**ADDENDUM #3**

**ITB# 2022-001**

**PROJECT: NORTH BAY VILLAGE BAYWALK PLAZA AREA NORTH - PHASE 1**

**DATE: 06/16/2022**

03 CONCRETE RETAINING WALL @ SEAWALL TYPE 3 NTS

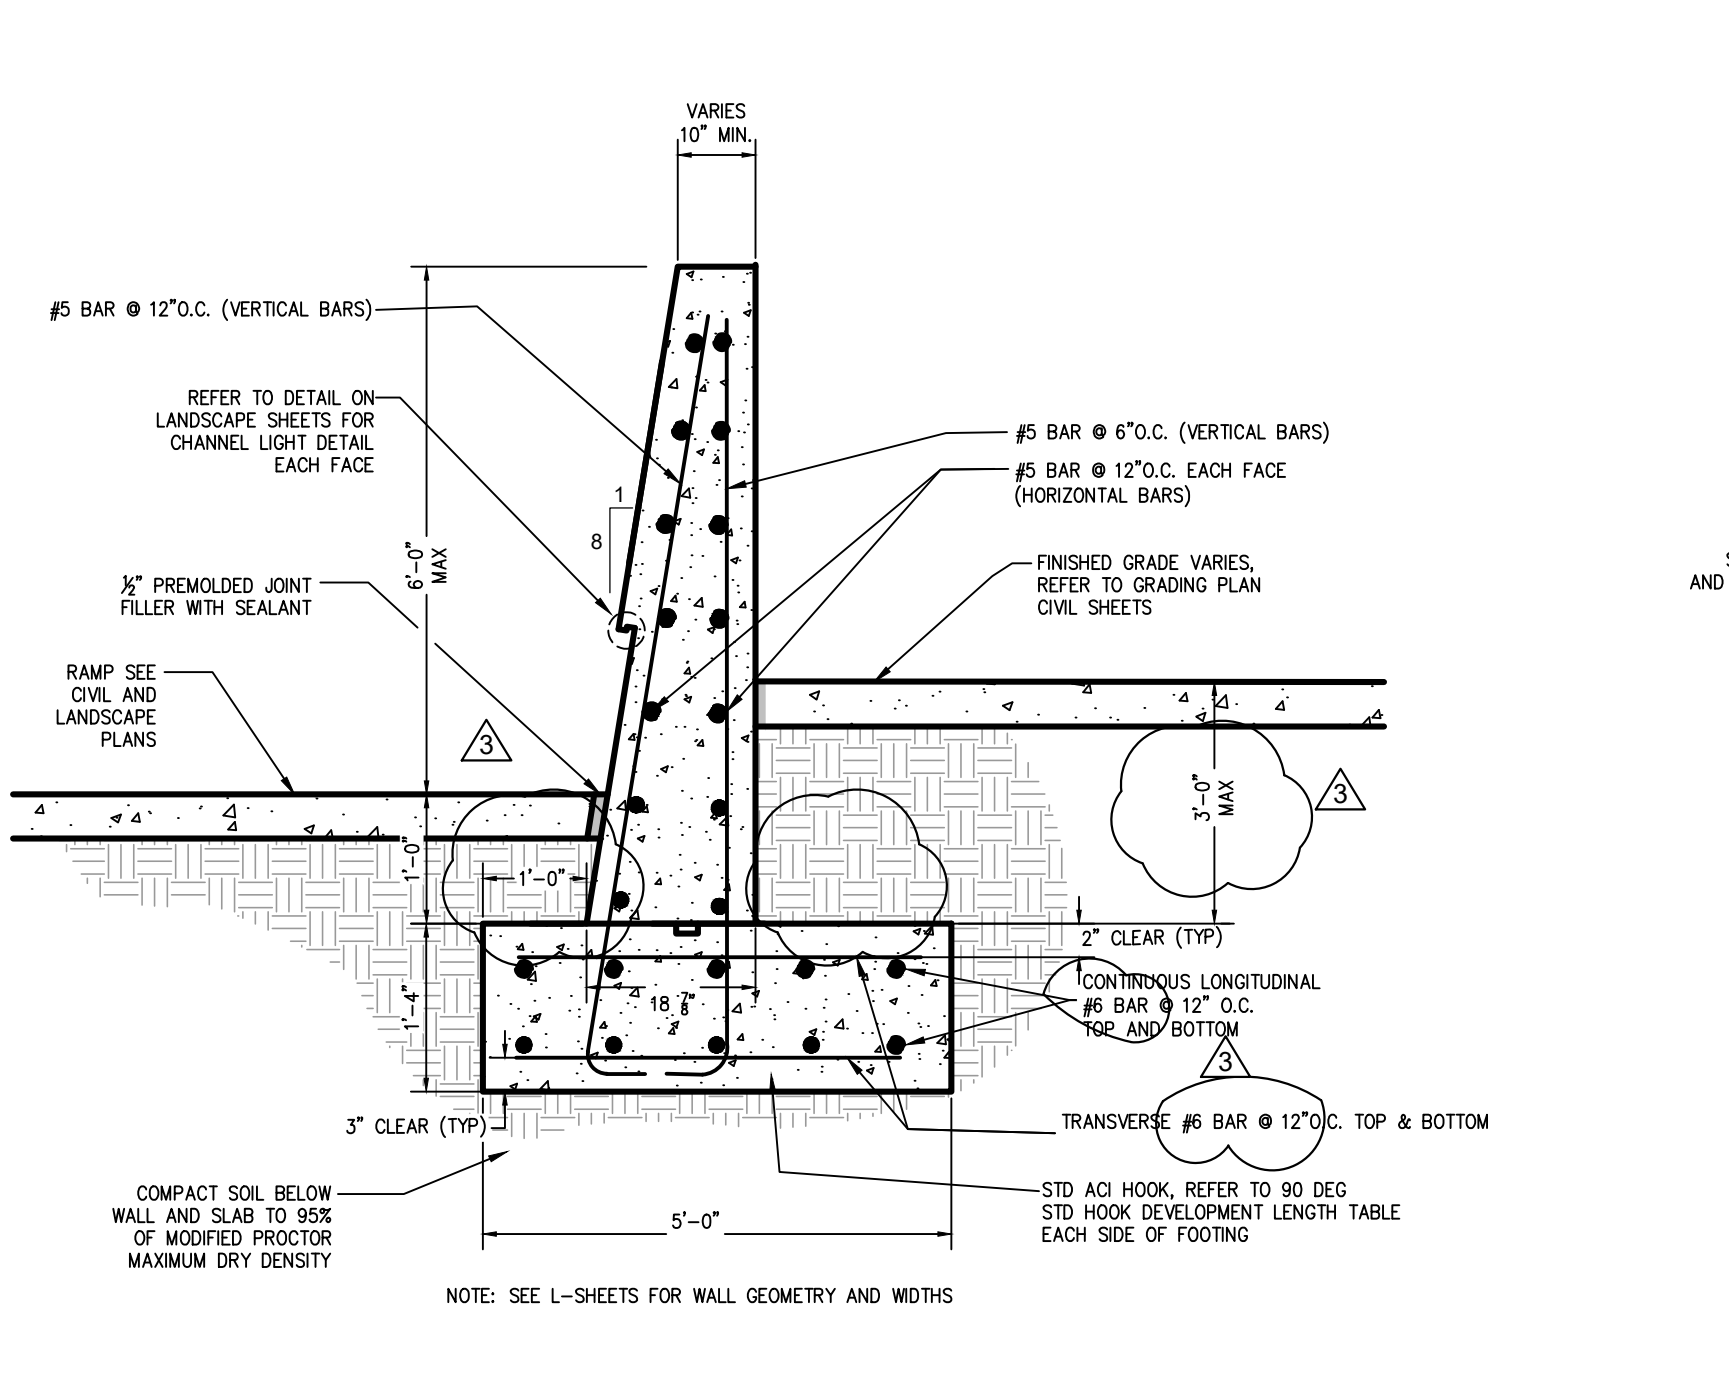
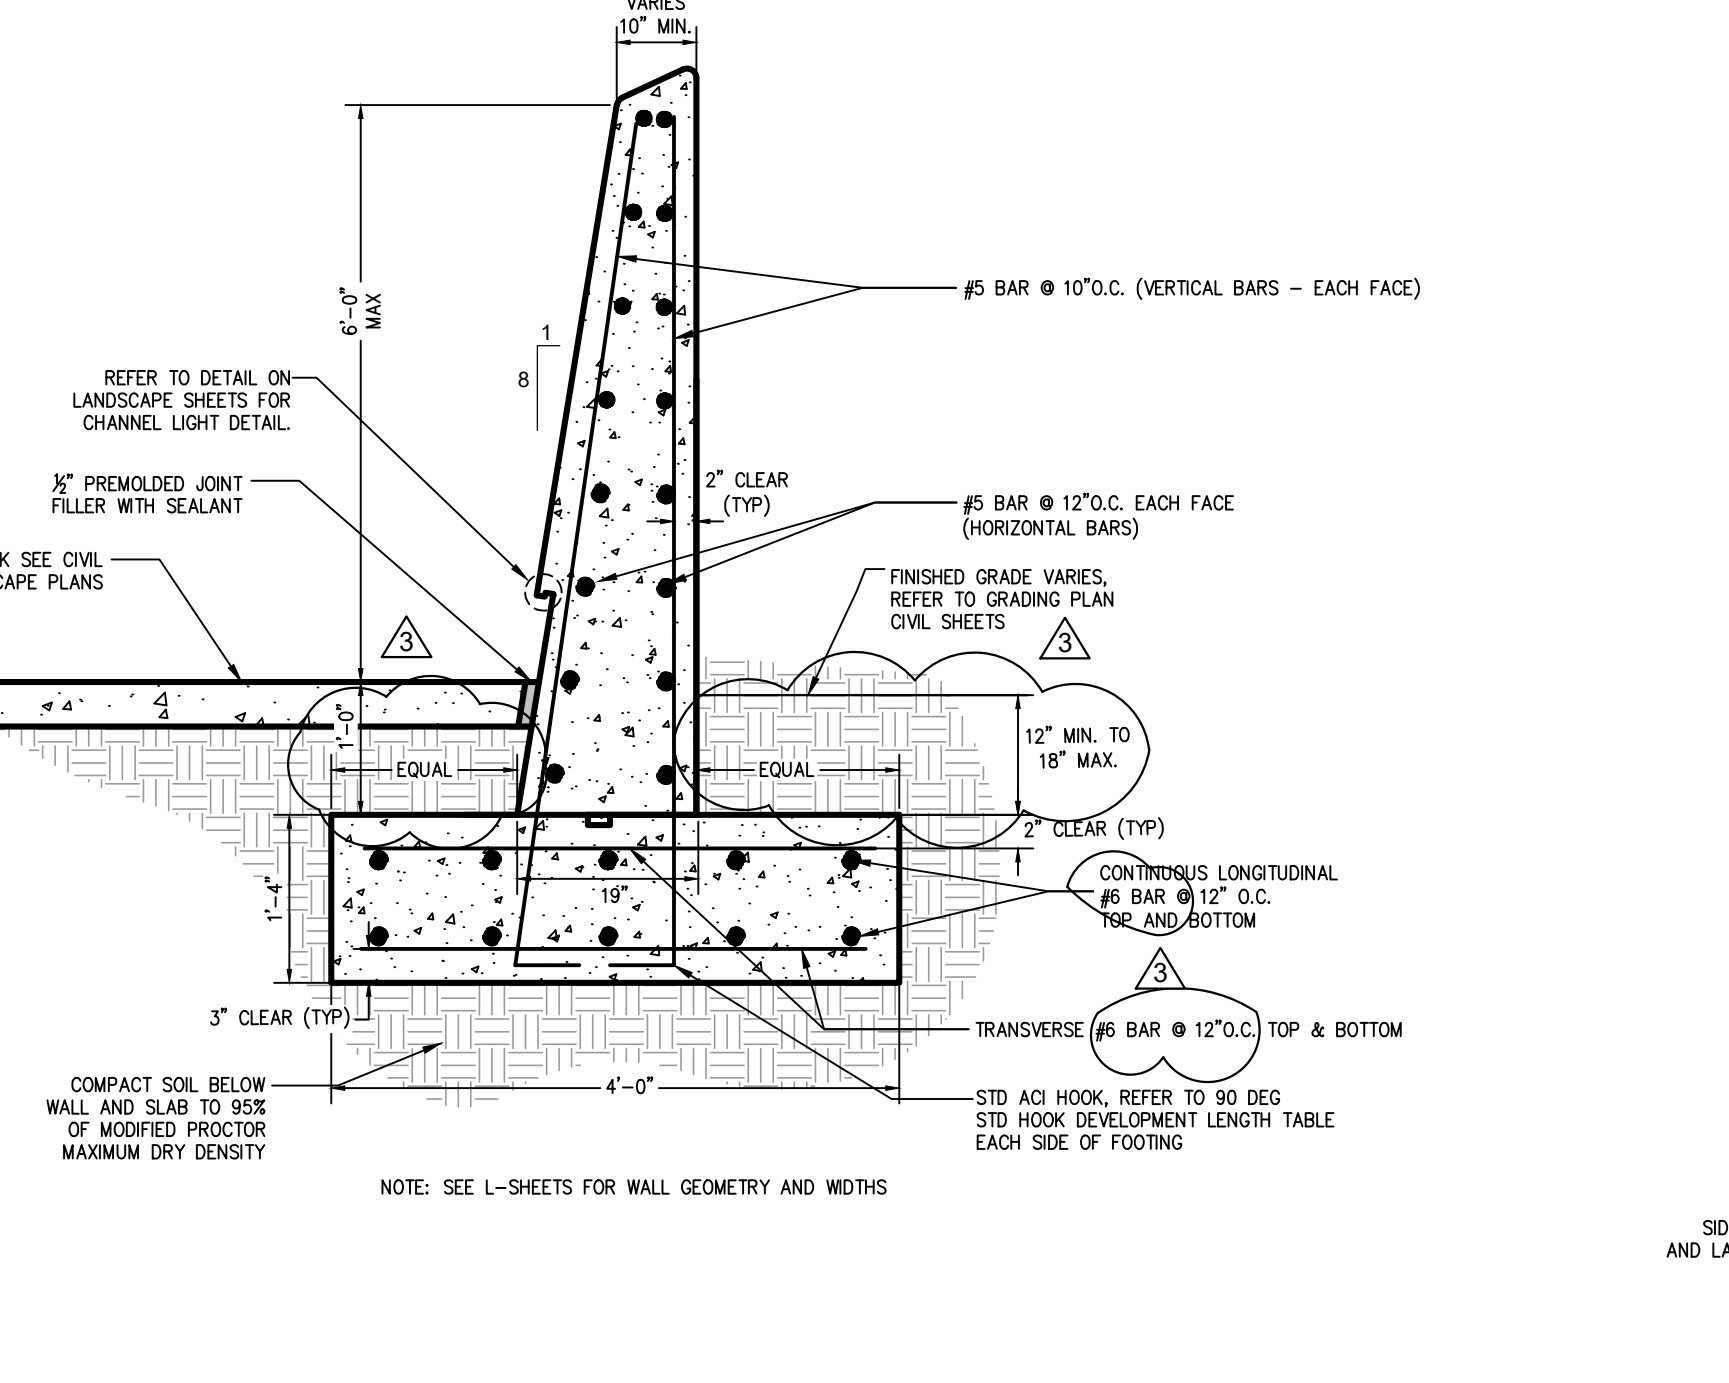
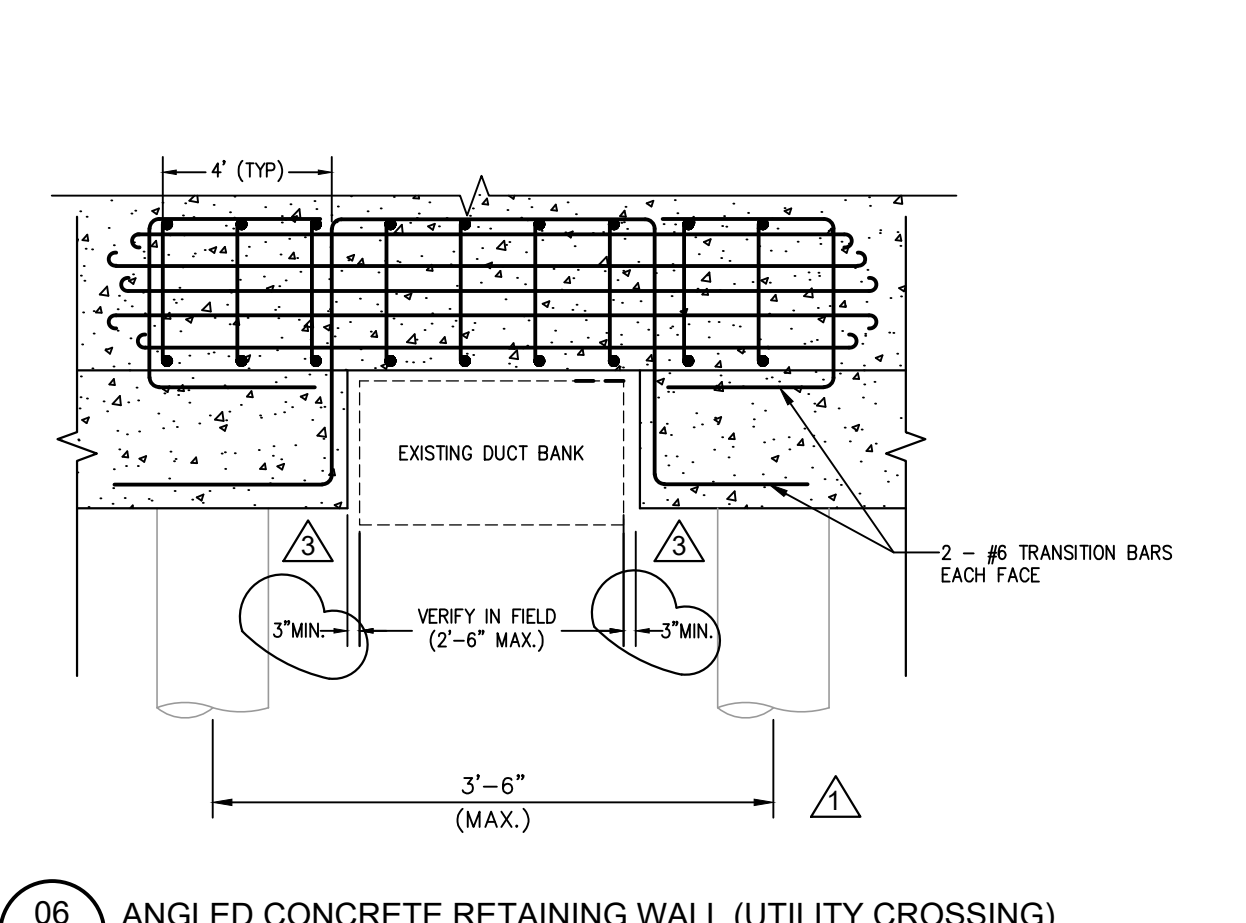
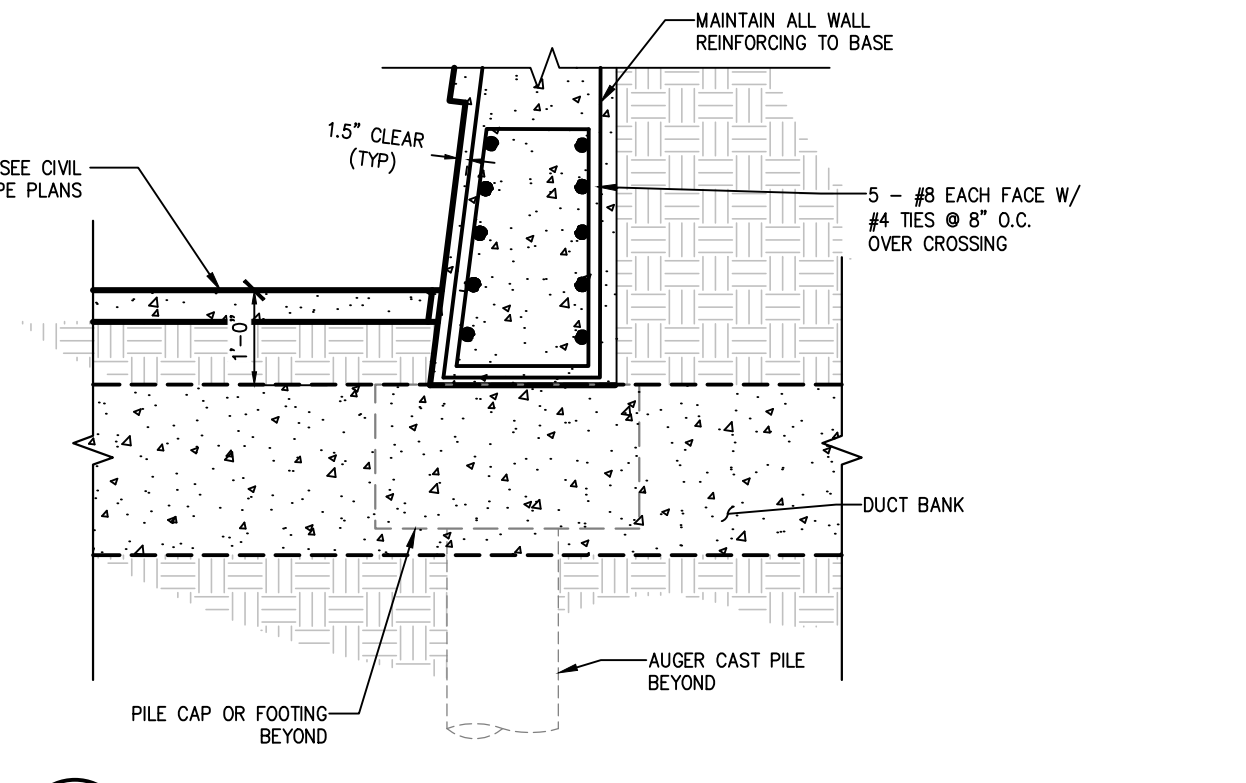
- **Attachment B – S-101 Structural Detail (Baywalk Plaza)** Replace with original set that says “Wellington Trace Traffic Calming for Town of Wellington” in the Title Block. Replace with correct sheet attached showing Baywalk Plaza North in the title block like other sheets of the bid plan set.
- **Plan Sheet L-352** - The North Pylon Monument Sign indicated in Plan Sheet L-352 indicates the name shown as “Baywalk Plaza”. This sign name has changed and is now “Island Walk Plaza “.

Revised S-101 sheet issued with Addendum No.3 for ITB2022-001 (revised 6/8/2022)
